SoilPure, Inc.

July 9, 2001

RE: Comments on the "Review of the Performance Demonstration Plan, Fields Brook Superfund Site, Ashtabula, Ohio."
submitted to Terese Vandonsel, RPM, USEPA Region V dated May 22, 2001 by Marta K. Richards, Engineering
Tech Support Center

Figure 2 -1 Performance Demonstration Test Project Organization and Responsibility

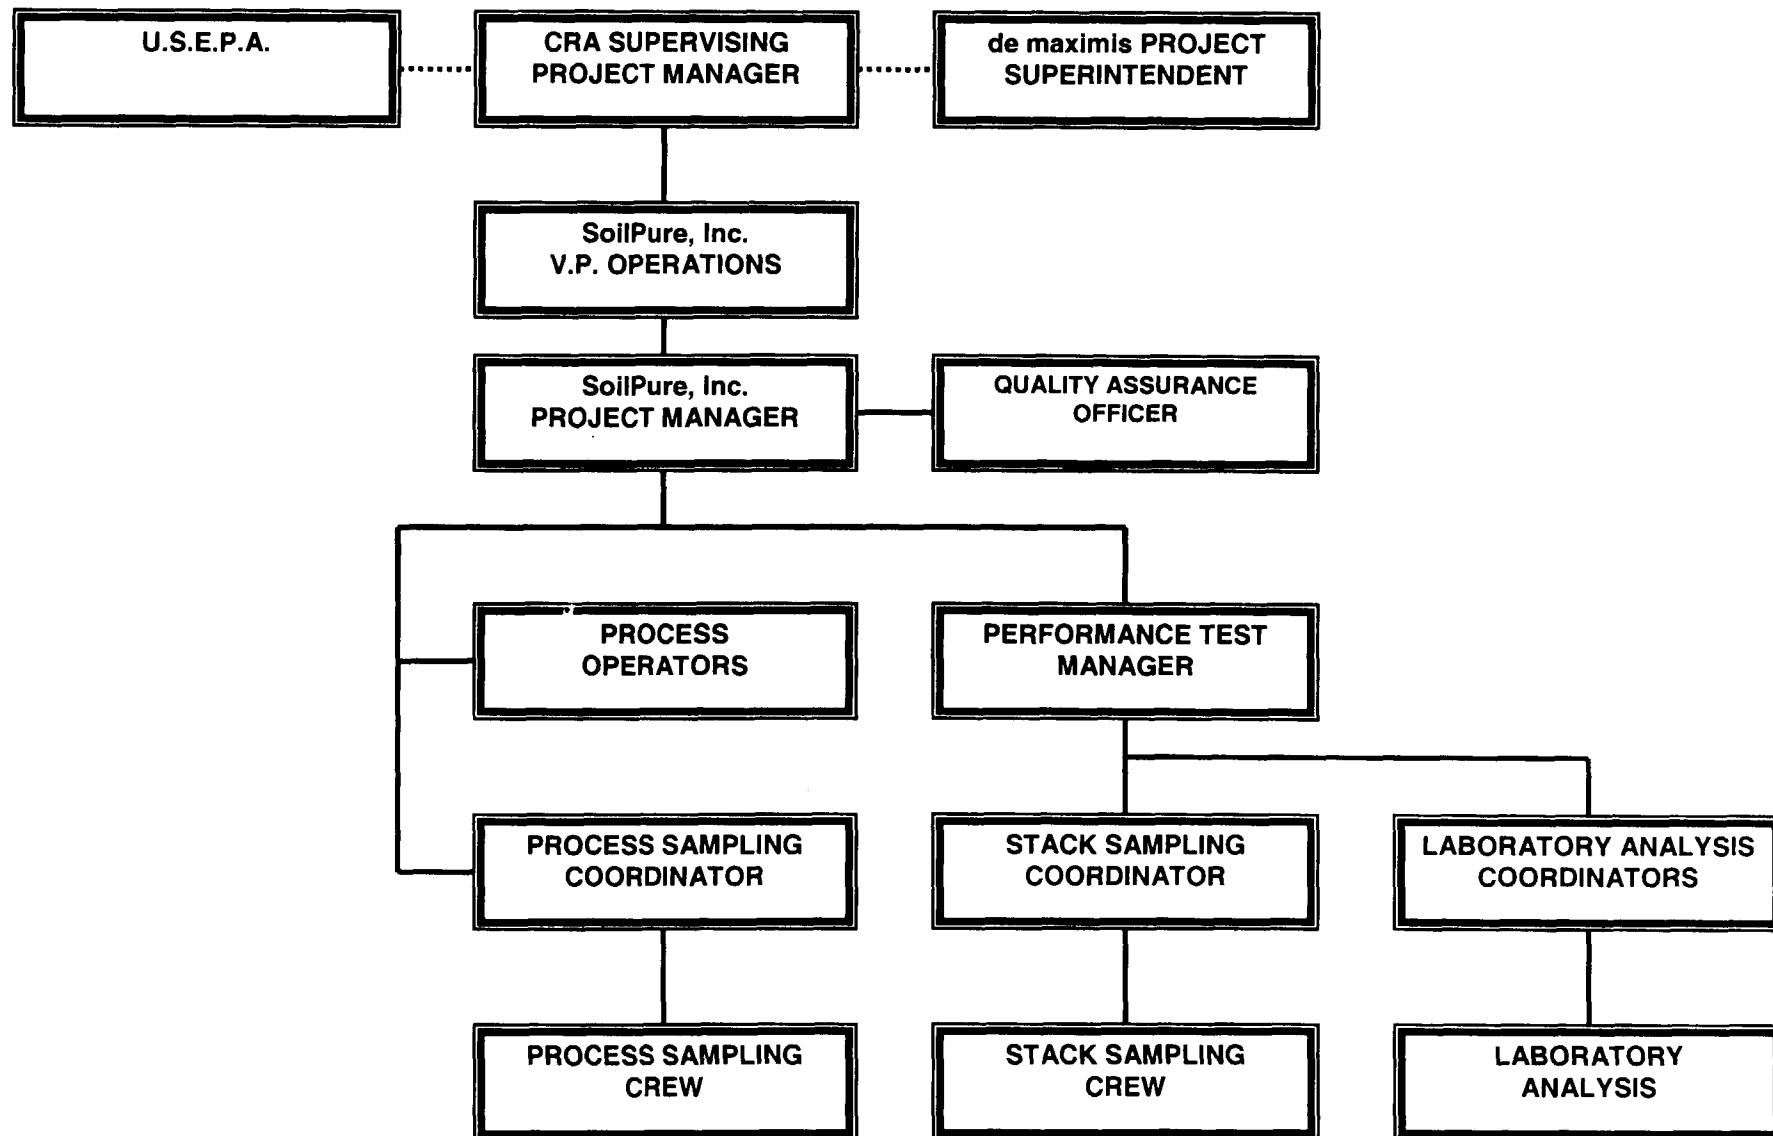
Paragraph 12 discusses the Organizational Chart. This has been changed please see the inserts for Section 2.
